Product Change Notice (PCN)

PCN Number: **PCN-0451528R-01**

Product(s) Affected: **PJ-064X**

Reason(s) for Change: **Factory Location Change.**

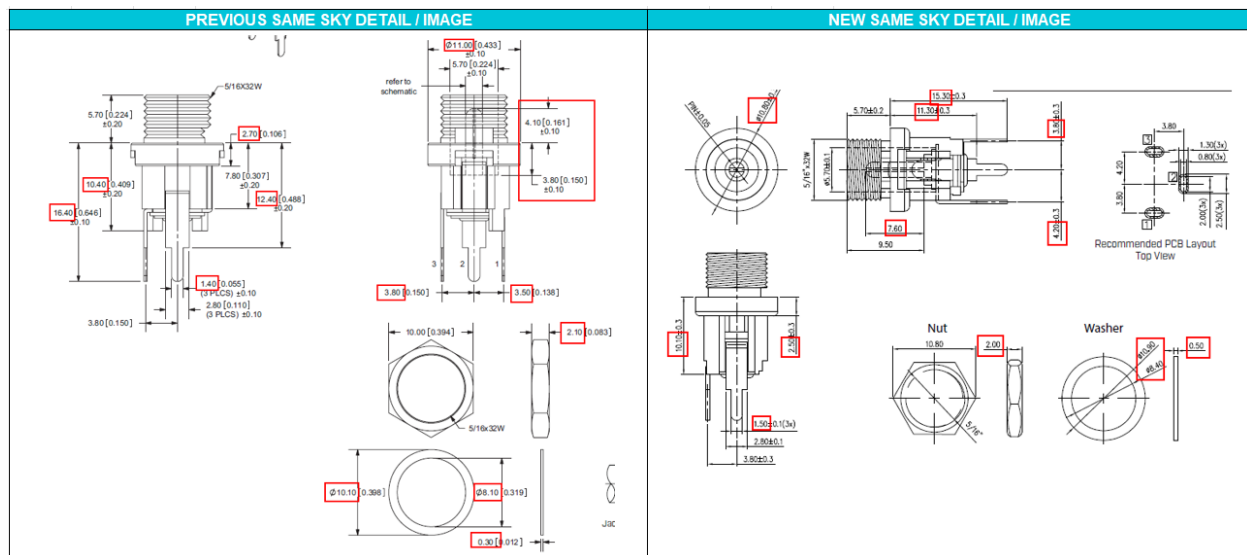
Description of Change: **Mechanical, material and electrical differences as shown in the detail image below.**

PCB LAYOUT
TOP VIEW

Recommended PCB Layout
Top View

MATING PLUG
Jack Insertion Depth: 8.4mm

MATING PLUG
Jack Insertion Depth: 9.5 mm

MATERIAL	PLATING
center pin	brass	nickel
terminal 1	brass	silver
terminal 2	phosphor bronze	silver
terminal 3	brass	silver
bushing	brass	nickel
insulator	red vulcanite fiber	
plastic	PBT	
nut	brass	nickel
washer	steel	nickel

DESCRIPTION	MATERIAL	PLATING/COLOR
center pin	brass	CuSn
terminal 1	C2680R ±0.40 mm	silver
terminal 2	C5210R ±0.50 mm	silver
terminal 3	C2680R ±0.40 mm	silver
bushing	brass	nickel
insulator	bakelite	---
housing	PBT (UL94V-0)	black
nut	brass	nickel
washer	SPCC	nickel
